**ADDENDUM NUMBER:** TWO (2)

**DATE:** February 17, 2026

**PROJECT:** LONE OAK COMMUNITY CENTER

**DESIGNER:** BRETT HARBISON, ARCHITECT  
MONTGOMERY COUNTY ENGINEERING

**C2.2**

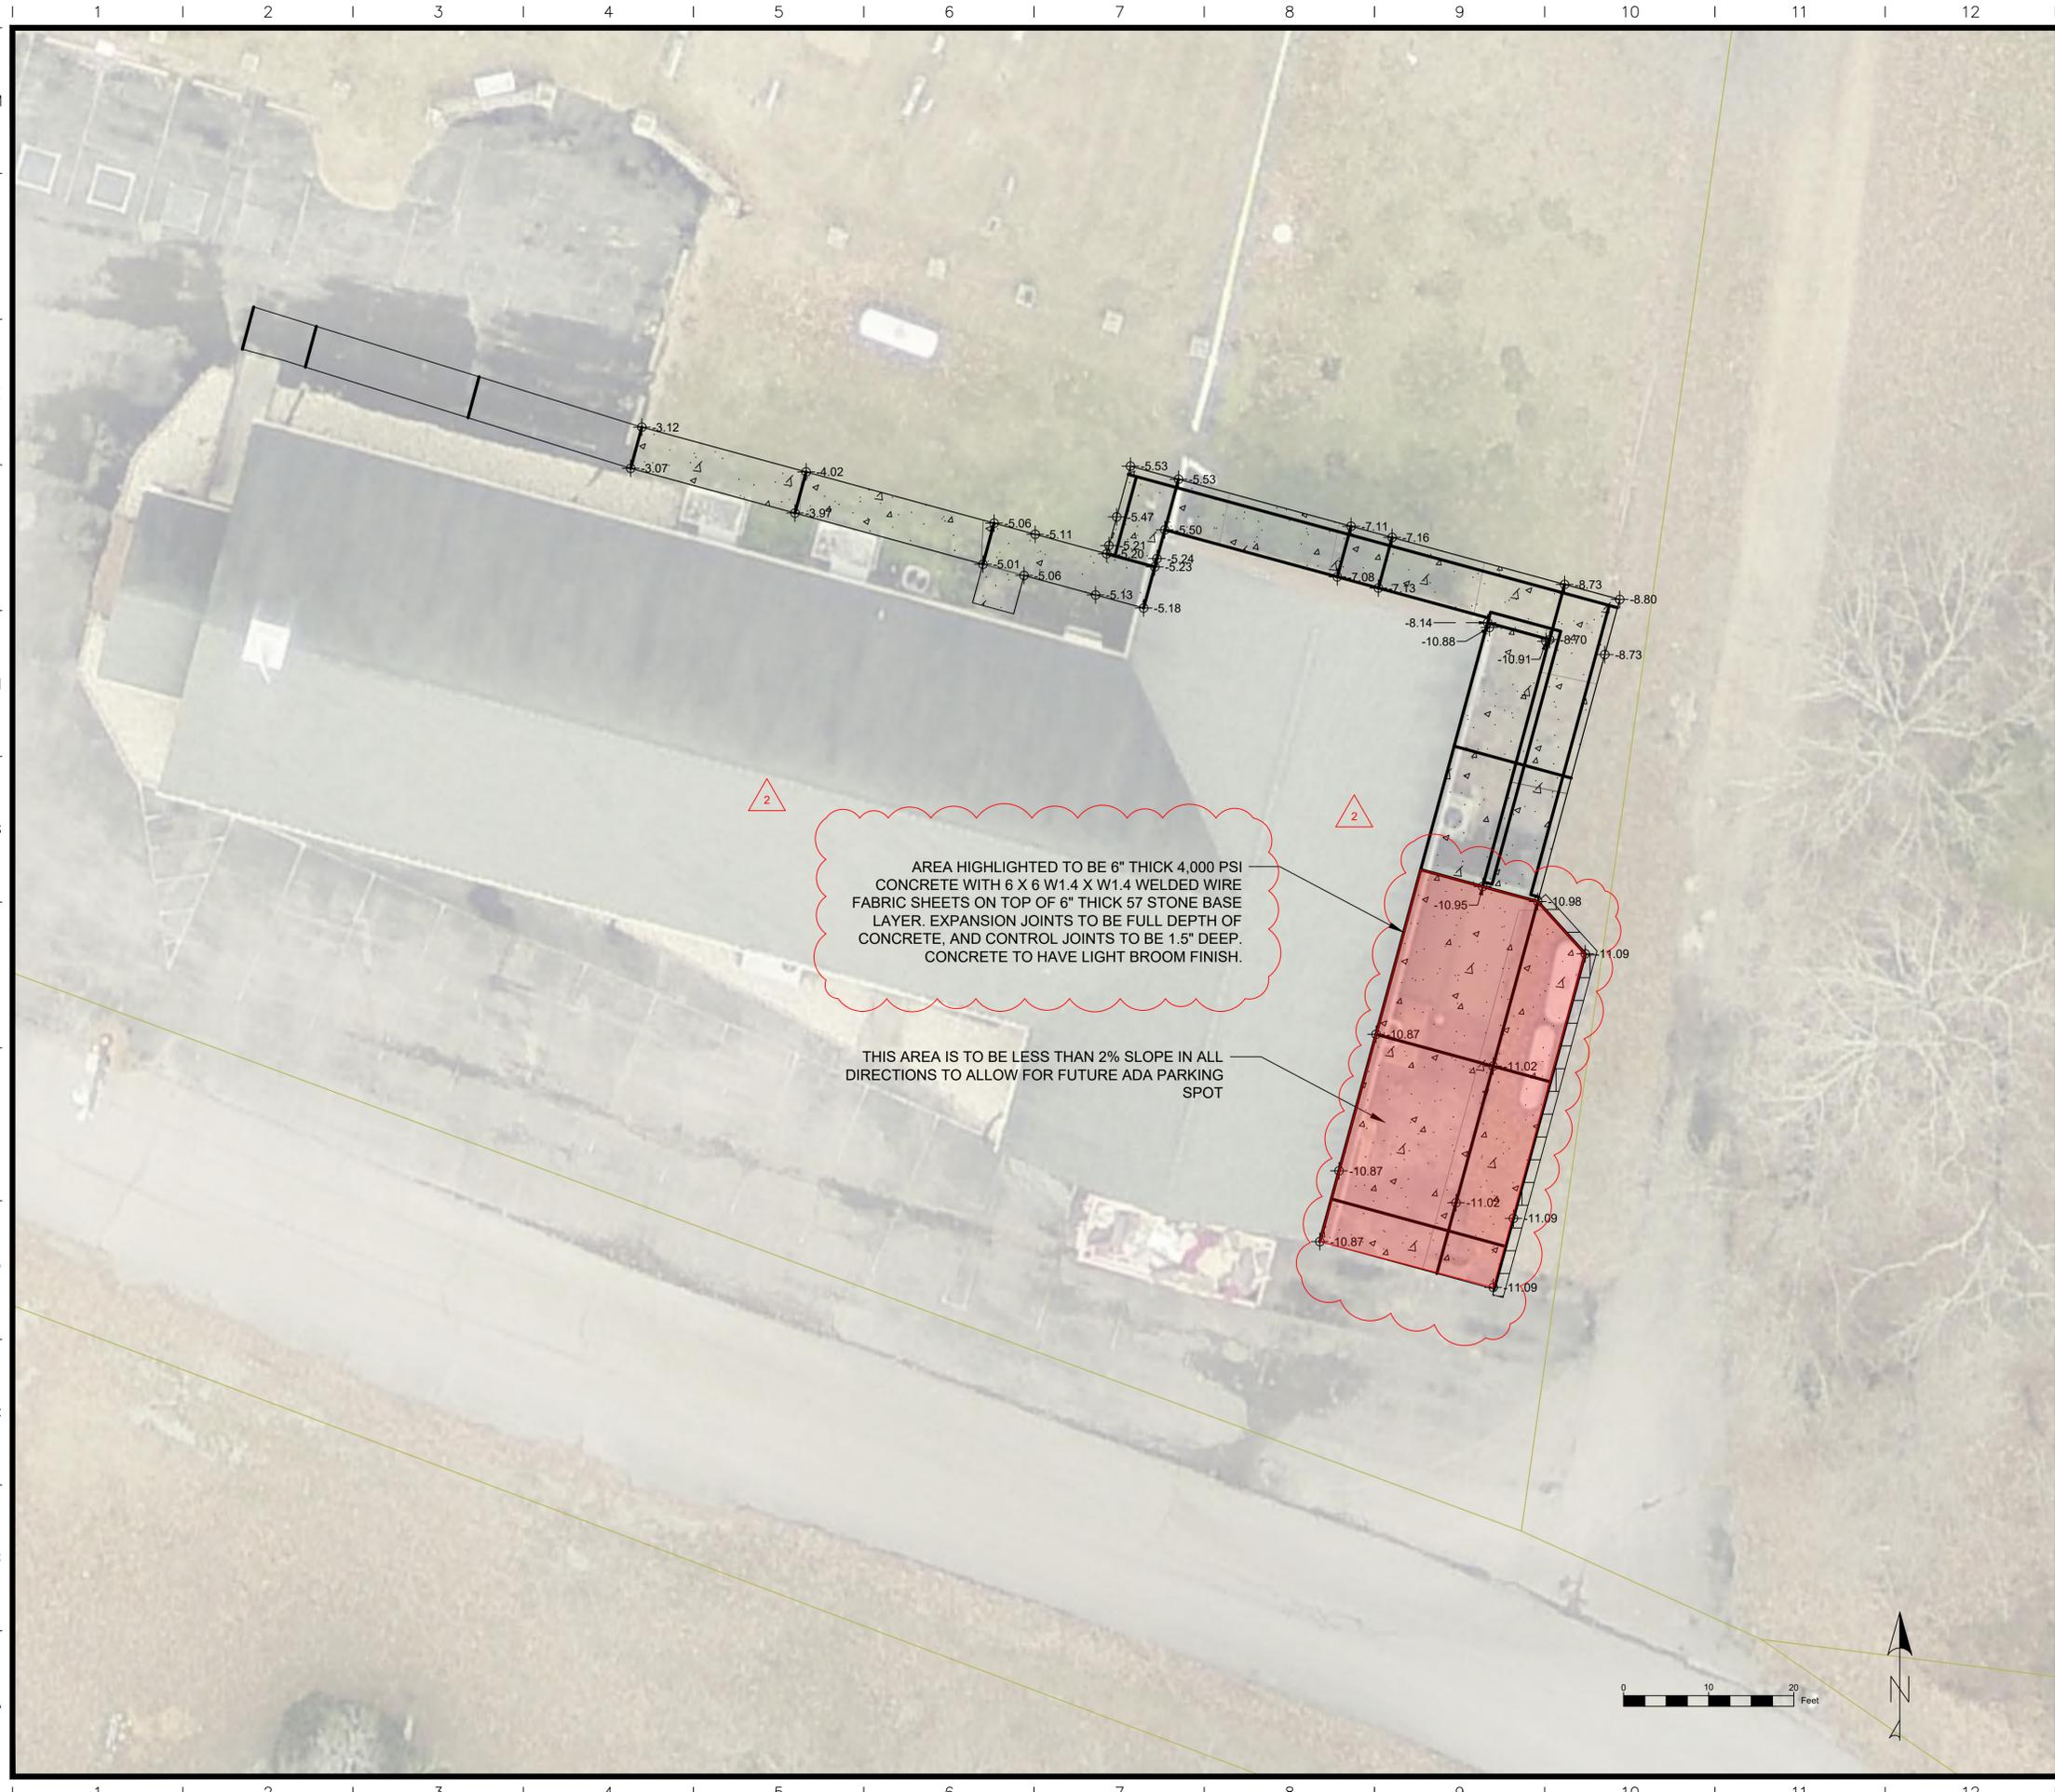
Parking Area highlighted to be 6" of concrete instead of normal 4" thick walkway. 6" of stone required as well.

AREA HIGHLIGHTED TO BE 6" THICK 4,000 PSI CONCRETE WITH 6 X 6 W1.4 X W1.4 WELDED WIRE FABRIC SHEETS ON TOP OF 6" THICK 57 STONE BASE LAYER. EXPANSION JOINTS TO BE FULL DEPTH OF CONCRETE, AND CONTROL JOINTS TO BE 1.5" DEEP. CONCRETE TO HAVE LIGHT BROOM FINISH.

# EX.1A

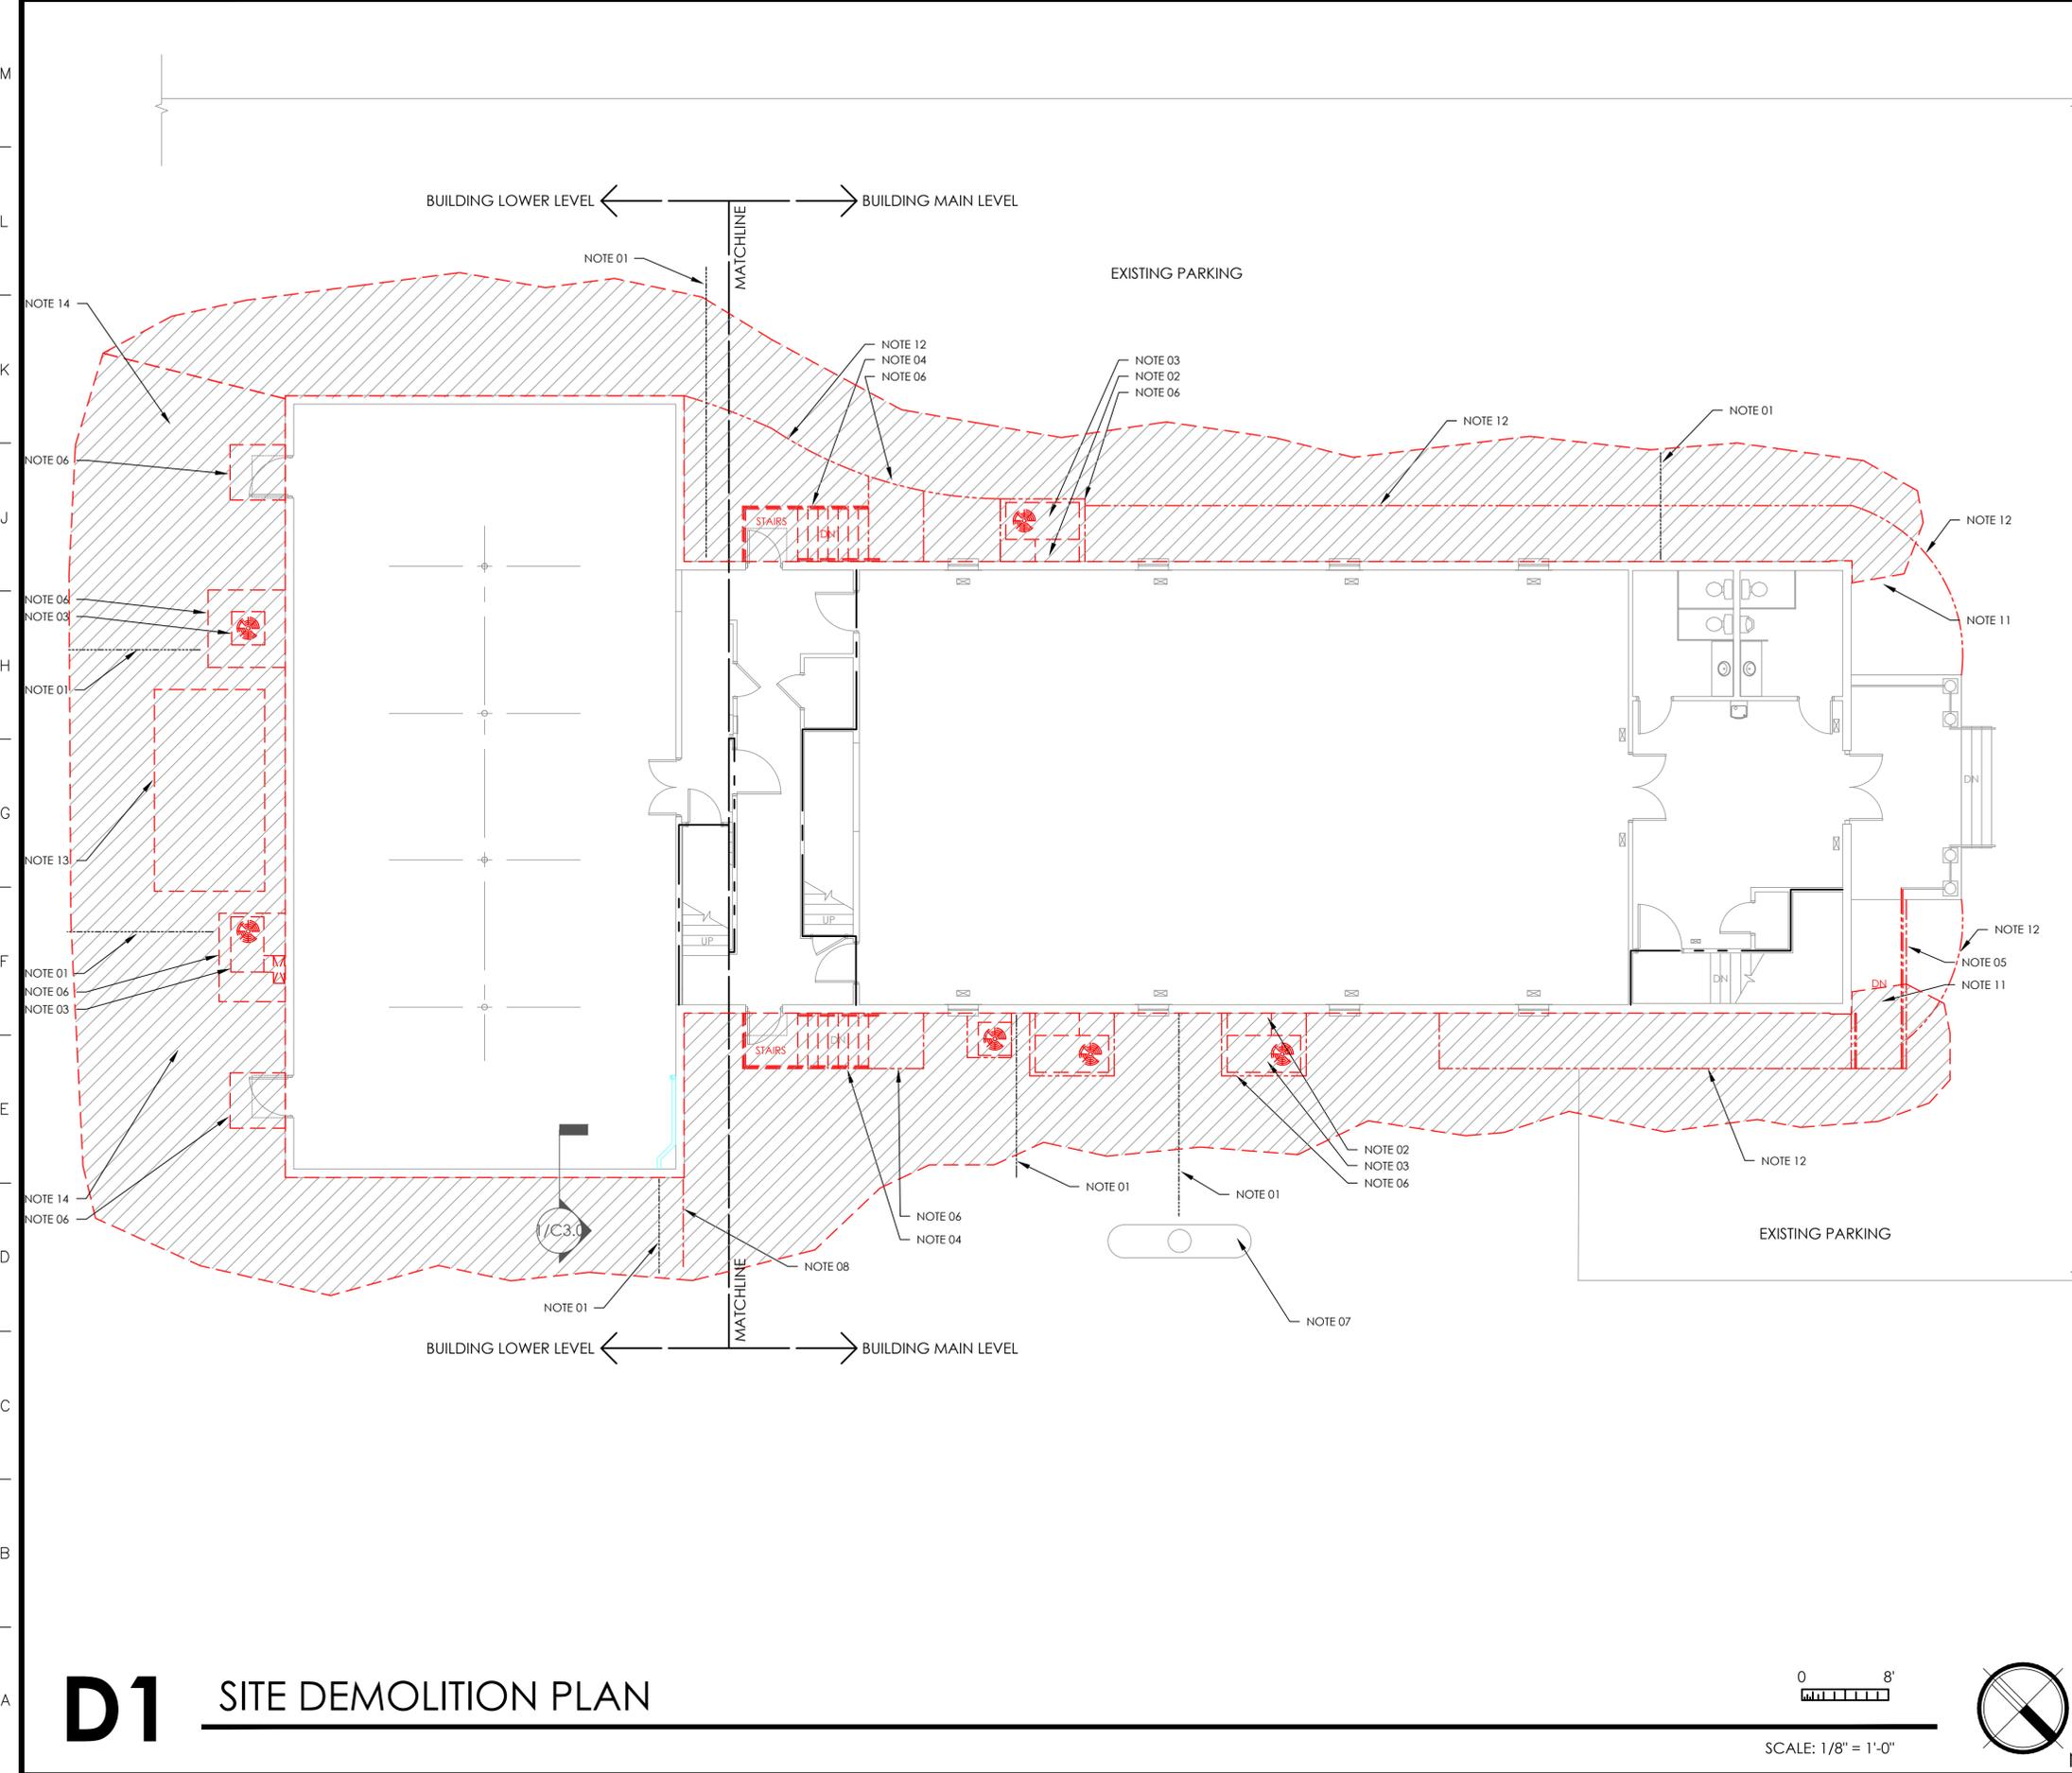
Revised General Notes.

# A1.1A

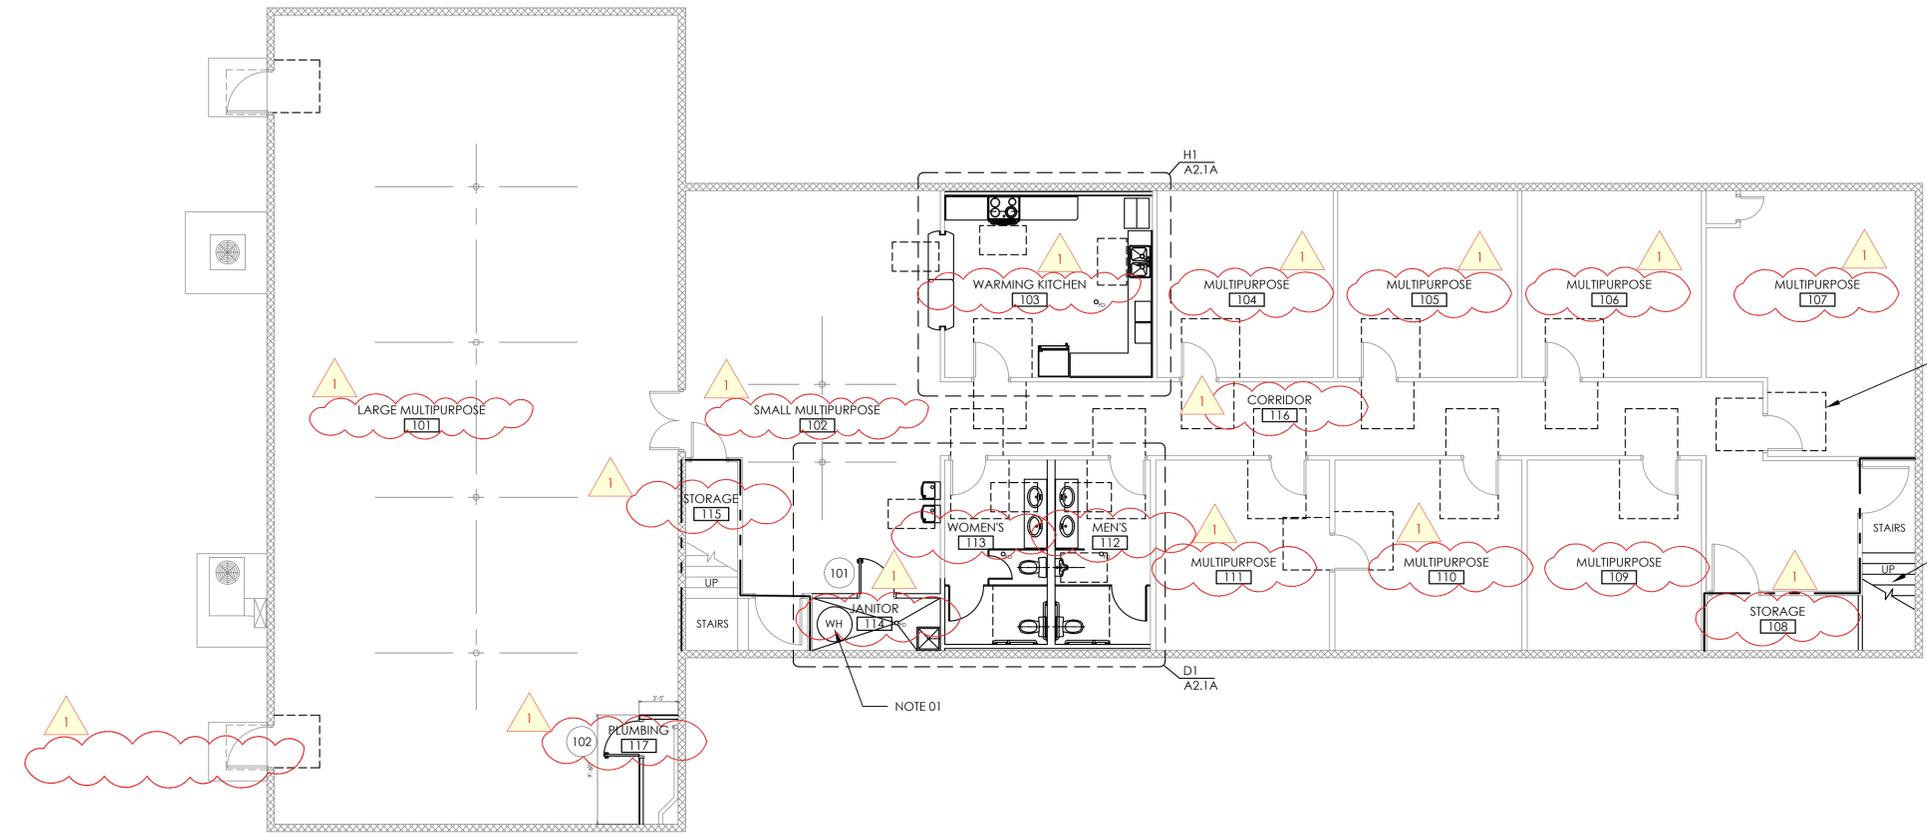
Corrected sheet name.  
Revised Key Notes by deleting Note 04.  
Revised General Notes to refer to sheets A2.1A and A2.3A for Enlarged Plans, Elevations and Details.  
Removed Note 04 callout.  
Added correct Room Names and Numbers.
